Consultancy Support for Ofgem's Cost Assessment of the proposed NSL Interconnector

Ofgem

24 June 2016

Figure 4-1 Cable unit costs comparison (EPC contract costs only)

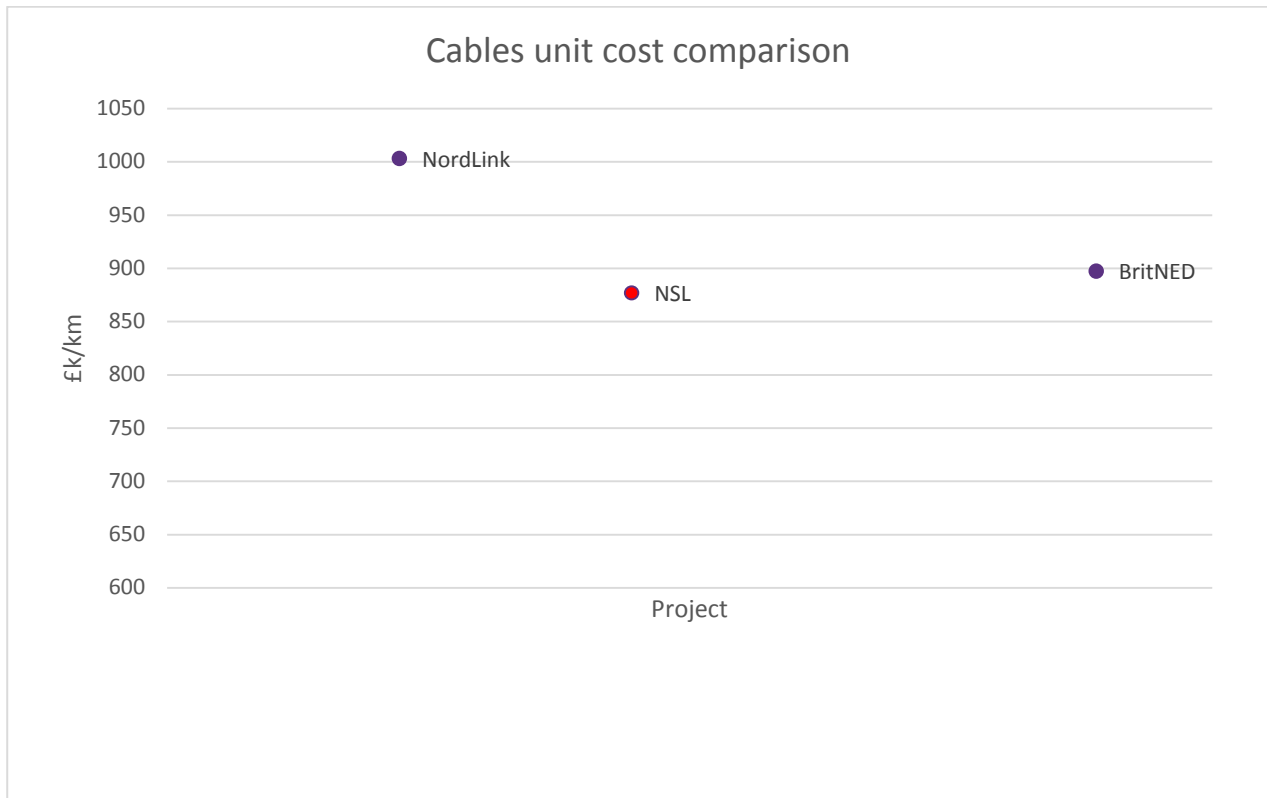
This comparison shows that NSL is cheaper than NordLink and almost on par with BritNED. In our opinion given the complexity of the project in terms of length and depth of installation this suggests a favourable price for the cable contracts. NordLink is possibly the project which serves best the purpose of a direct comparison both in terms of market conditions at the time of signing the contracts and the complexity of the projects.
